RE: Conditions of Project Approval # 3, 42, 54, 59, 60 and 66: 1024 and 1026 Grayson Road, Pleasant Hill; County File: #CDS20-09581

Re: Calibr Venture’s Response to Appeal of CDSR 20-09531 1024 and 1026 Grayson Road Pleasant Hill, Vesting Tentative Map, Density Bonus, and Mitigated Negative Declaration

To: Andy Byde, Calibr Ventures
From: Sadie McGarvey, Integral Consulting Inc.
Date: January 3, 2024
Subject: Grayson Road 10-Lot Subdivision Project – Response to California Wildlife Foundation Comment Letter

TREE
MITIGATION
PLAN

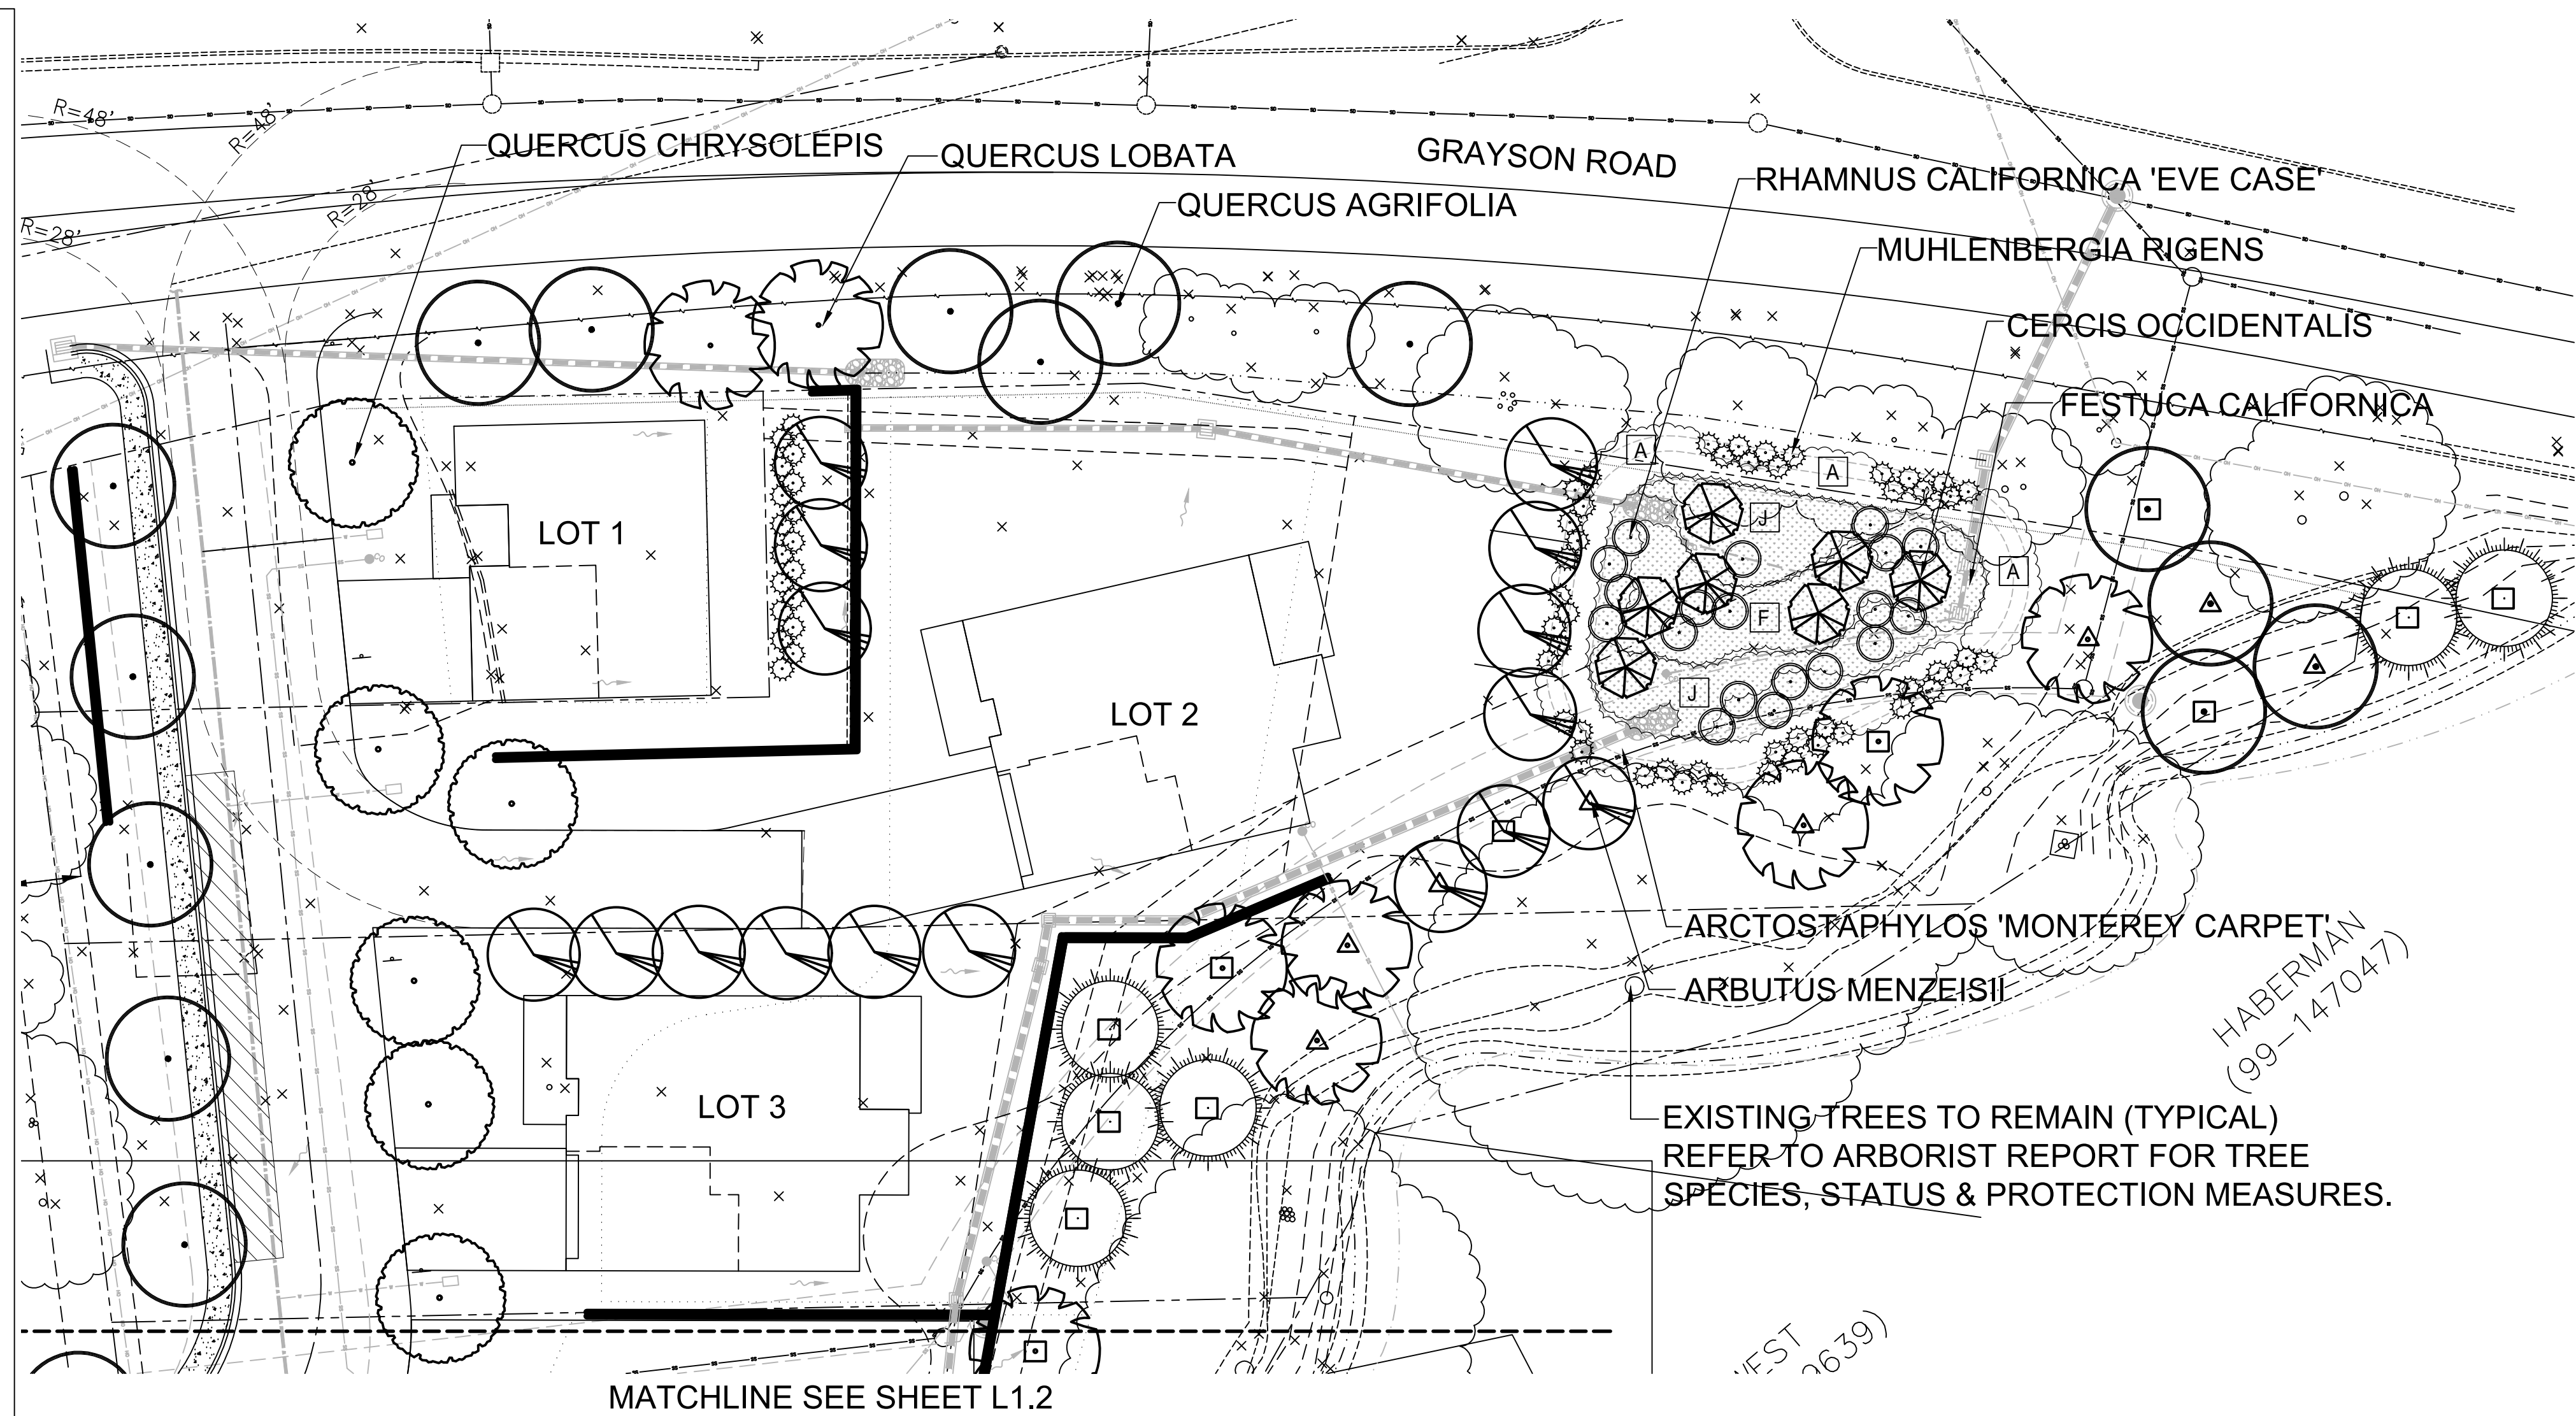
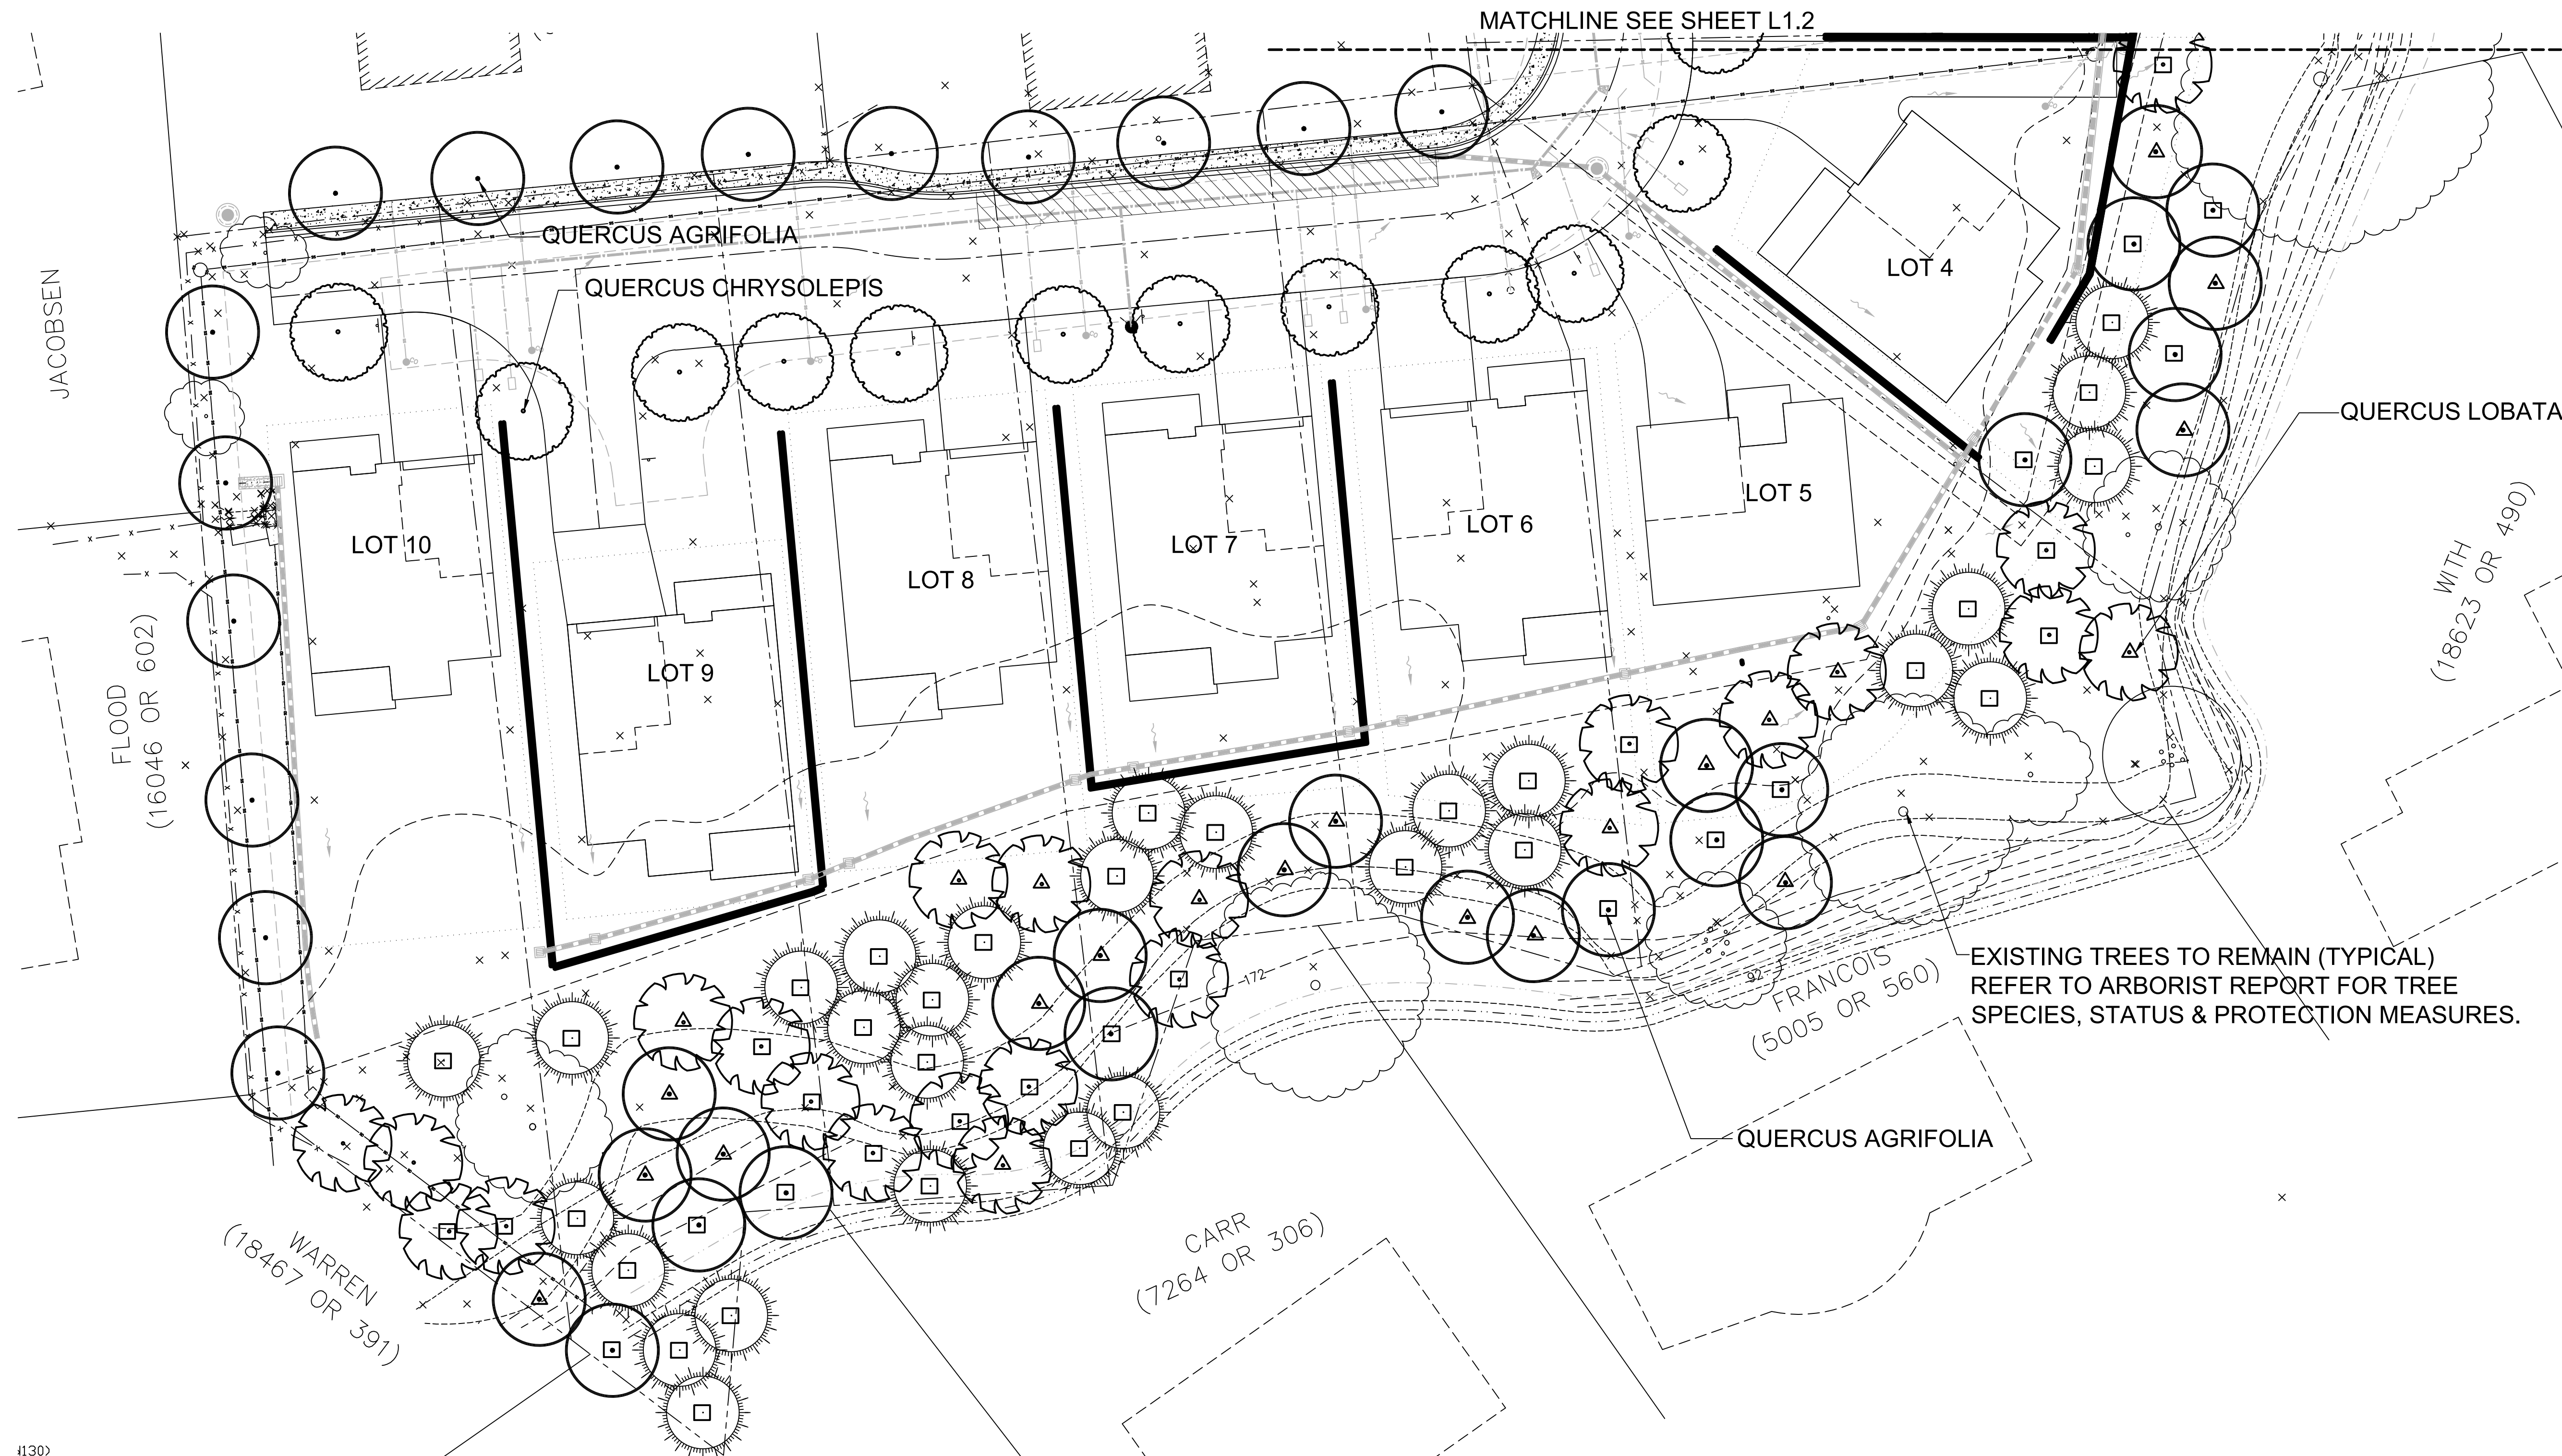
Inconsistencies in the numbers of trees to be removed and to be planted as mitigation have come to light.

The Tree Mitigation Plan states the following:

84 trees removed that require 3:1 mitigation. Calls for planting of 252 15 gallon trees. Then states 158 trees provided: 67 24-in. box size, 63 15-gallon, and 32 5-gallon.

It would appear that the County's determination of 58 trees to be removed is significantly lower than what will actually be removed according to the biological report, so please explain this number. It also appears that there are inconsistent

tree numbers to be removed included in the IS/MND, biological report and mitigation plan. The IS/MND claims that 158 trees are required to mitigate the loss of 58 trees, yet the planting plan identifies the need for 252 trees but provides only the 158 called for in the IS/MND. **Please clarify how many trees will be removed and how many will be planted as the County's proposed mitigation. Please explain the inconsistencies I have identified above. Please explain the numbers in the IS/MND - where they came from and if the County still believes they are correct. Also, please point out where in the biological report and the IS/MND the explanation is presented regarding how the proposed mitigation will compensate for the permanent loss of 2 acres of oak and mixed woodland habitat and the permanent loss of 2 acres of wildlife habitat.**
